THE HAVEN SHD

ARCHITECTURAL STATEMENT OF RESPONSE TO ABP OPINION
PROPOSED BUILD TO RENT MIXED USE DEVELOPMENT
BELGARD SQUARE EAST, BELGARD ROAD AND
BLESSINGTON ROAD, TALLAGHT, DUBLIN 24

MAY 2022

02.2 ITEM 1: MIX OF USES - INCREASED RETAIL PROVISION

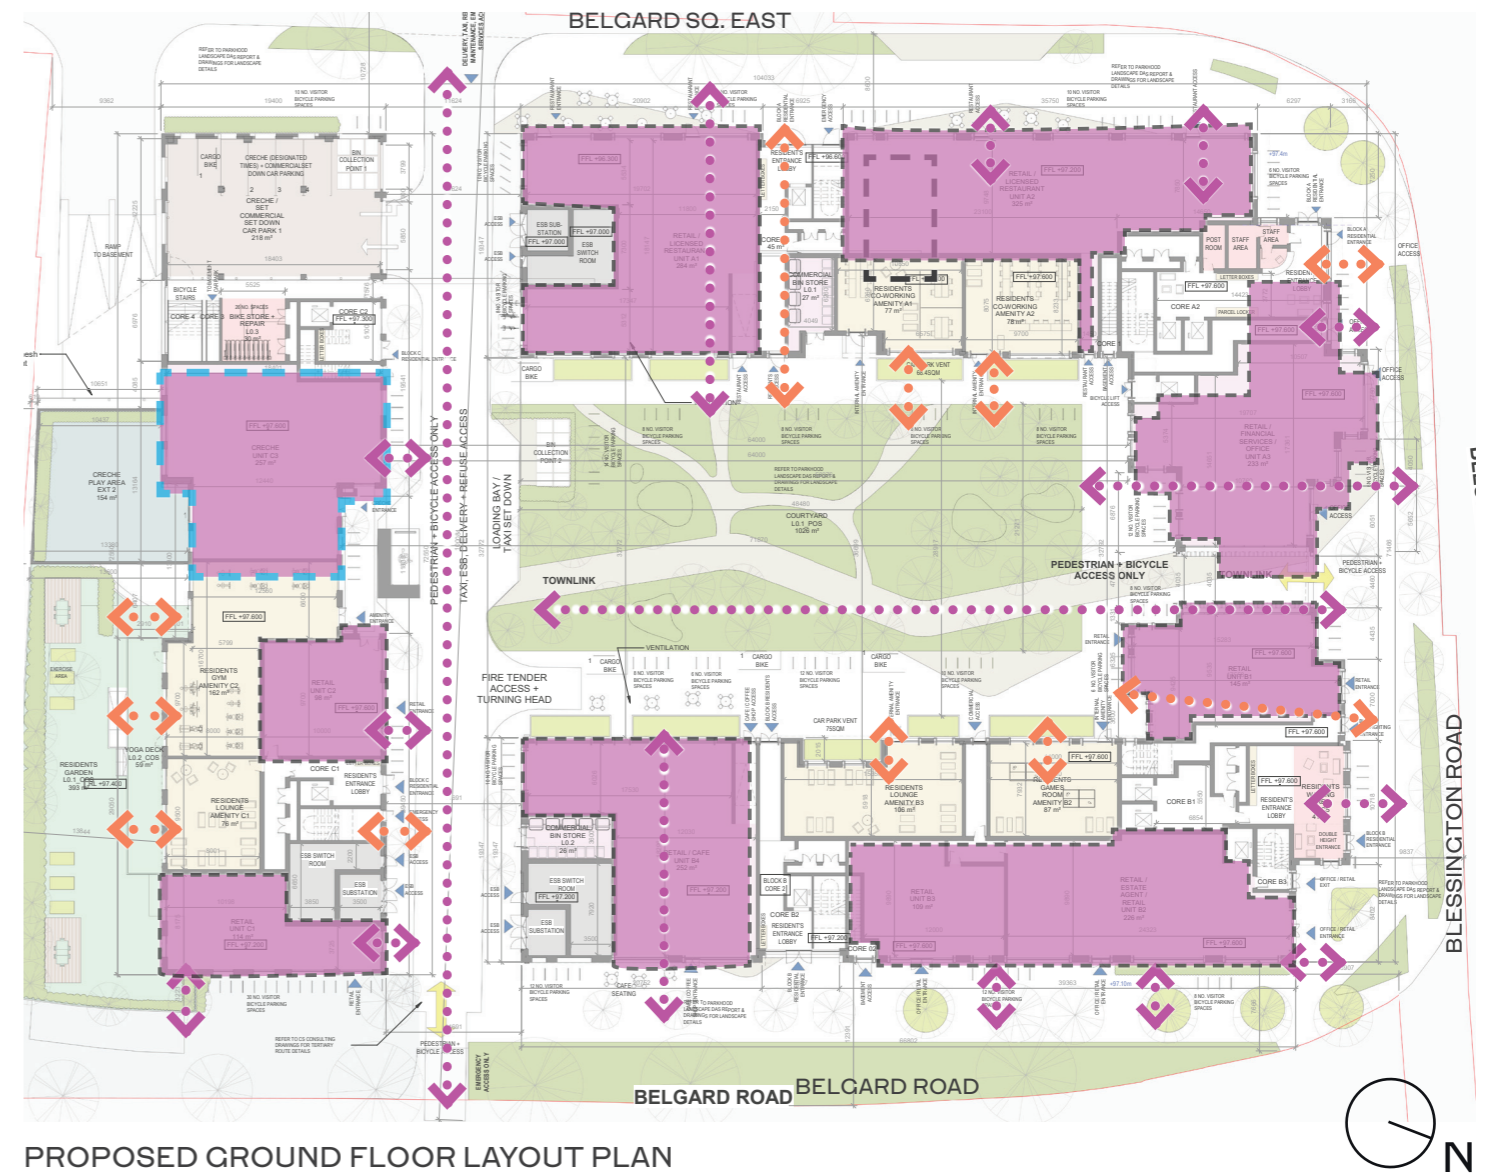
1. A detailed Statement of Consistency and planning rationale, outlining how in the prospective applicant's opinion, this primarily residential development is in compliance with the policies of the County Development Plan for this area.

Such statement should have regard in particular to the "Town Centre" land use zoning objective and the identification of this as a Retail Opportunity Site, as well as the provisions of section 2.4.2 of the LAP relating to Mixed Use Frontage in such locations.

GFA Retail/Commercial (Retail / Office / Creche) 1640 sqm

Basement: GFA Retail/Commercial (retail / office / creche)	66 sqm	Overall GFA (Commercial)	7%
GF: GFA Retail/Commercial (retail / office / creche)	2,096 sqm	Ground Floor Area (Commercial)	57%
1st floor: GFA Retail/Commercial (Retail / Office / Creche)	127 sqm	GFA Commercial Increase:	40%
Total Provision	2,289

02.8 ITEM 2: OPINION - HEIGHT, SCALE & DENSITY

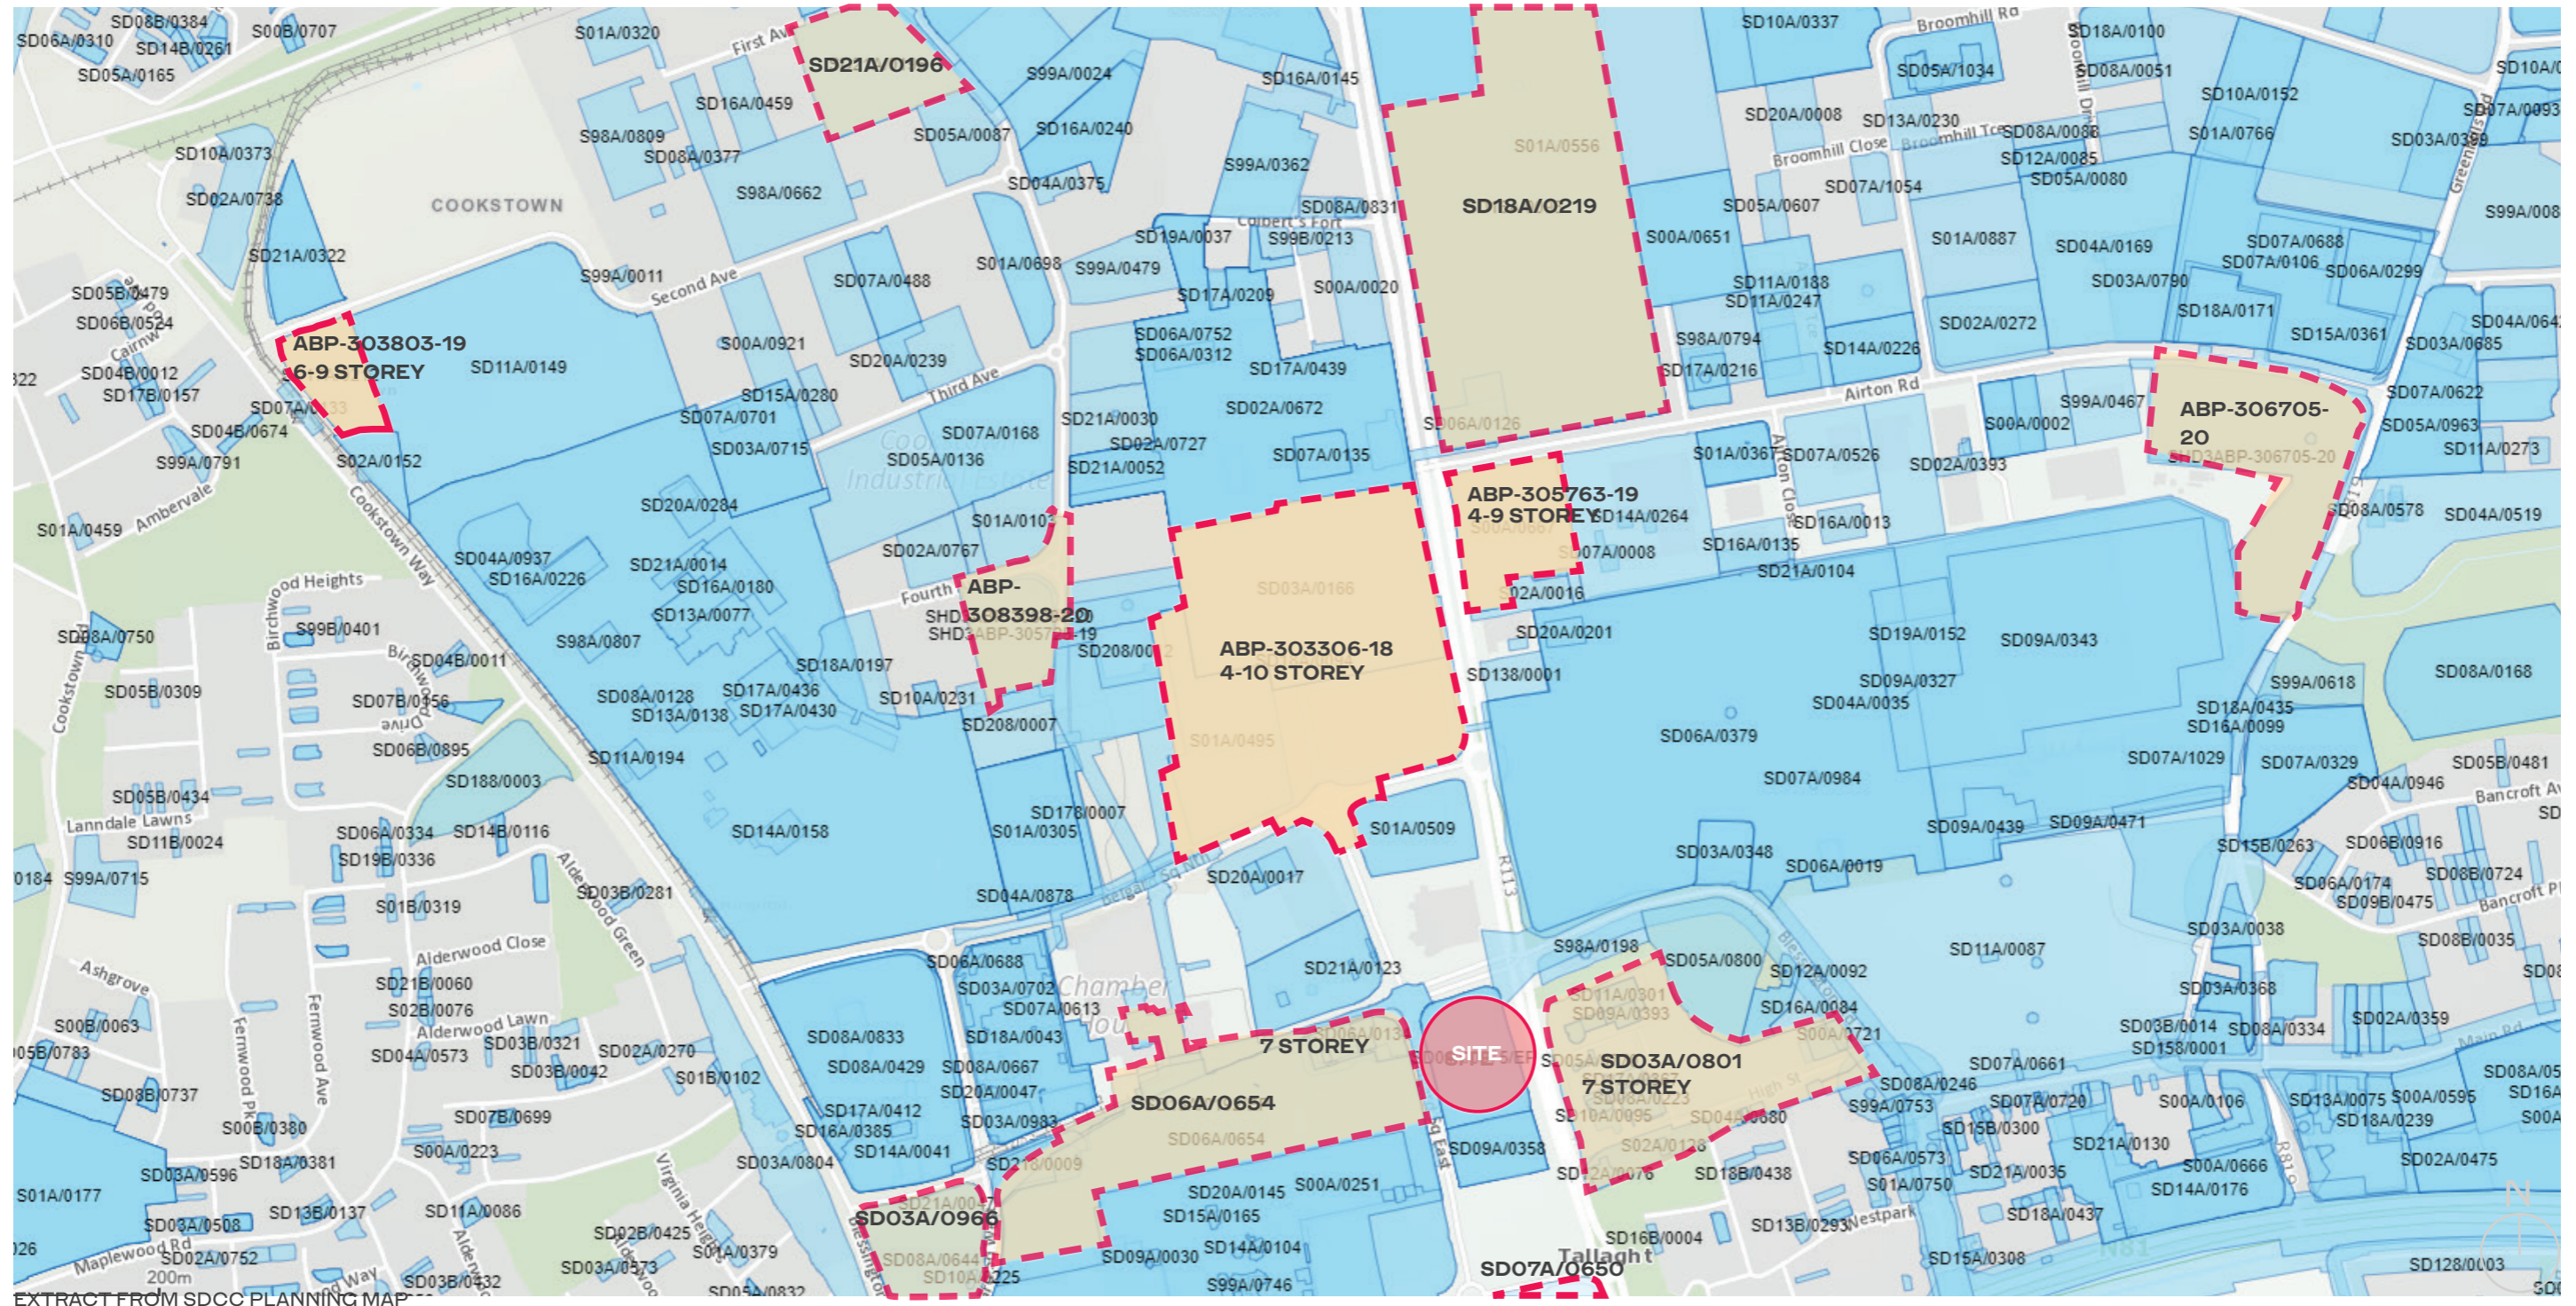
2. Further consideration / justification of the documents as they relate to the height, scale and density of development proposed. In this regard the application should be accompanied by a detailed Rationale / Justification for the proposed density and building heights, having particular regard to section 2.6 of the Tallaght Town Centre LAP 2020 in respect of Intensity of Development and section 3.2 in relation to The Centre, and the provisions of the County Development Plan in this regard, as well as the criteria set out in Section 3.2 of the Urban Development and Building Height, Guidelines for Planning Authorities' 2018.

In addition, following on from the Pre-App Meeting, in response to this item, at some higher areas of the proposed, a change in material is proposed. This gives animation to the elevation, variety in materiality and the impact of massing, and helps to tie the proposed in with the surrounding context.

03.4 ITEM 4 : WIND ANALYSIS

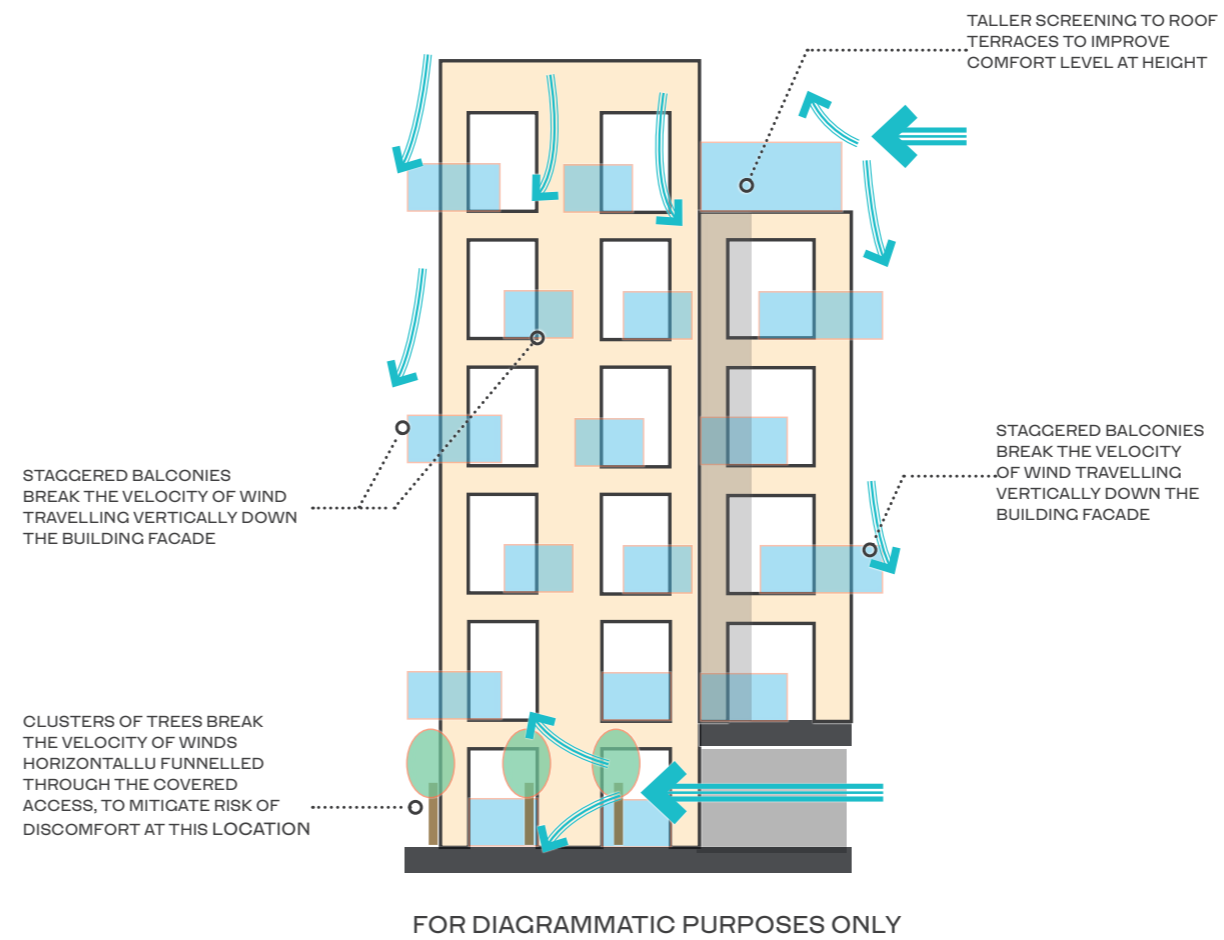
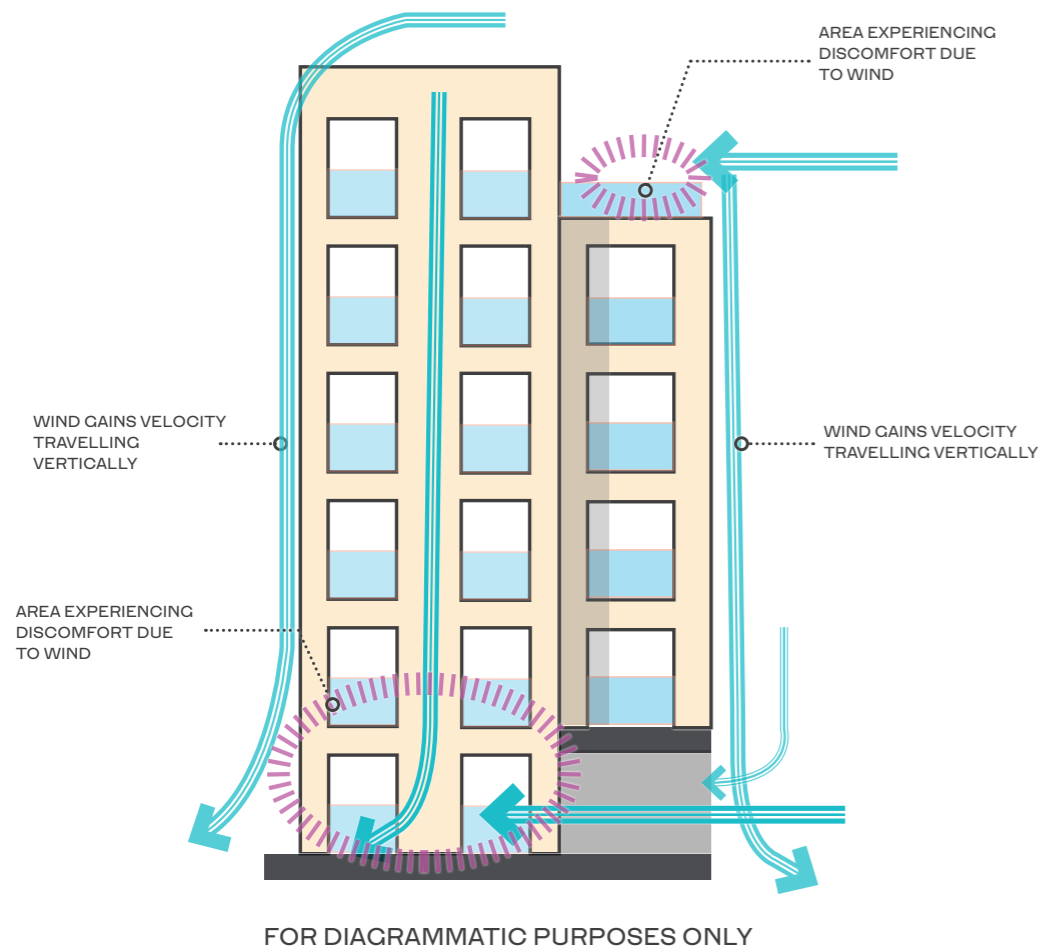
4. Any required mitigation or other design measures arising from such assessment should be clearly identified and described in the study.

Mitigation measures carried out:

At the very outset of the design process B-Fluid were consulted on what measures could be incorporated within the design, prior to testing, to reduce impacts of wind to the public realm to the perimeter of the site, and to the public open space.

The measures carried out are as follows:

- Staggered balconies;
- 1500mm glazed balustrades to rooftop terraces;
- Clusters of trees & planting to public open space to break any potentially higher velocity wind funnelled through the covered access route to the north of the site;
- Further measures carried out to mitigate the potential for the proposed massing to function as a wind funnel, and to improve comfort levels, such as proposing any seated areas away from where analysis shows there will be a potential for stronger winds.
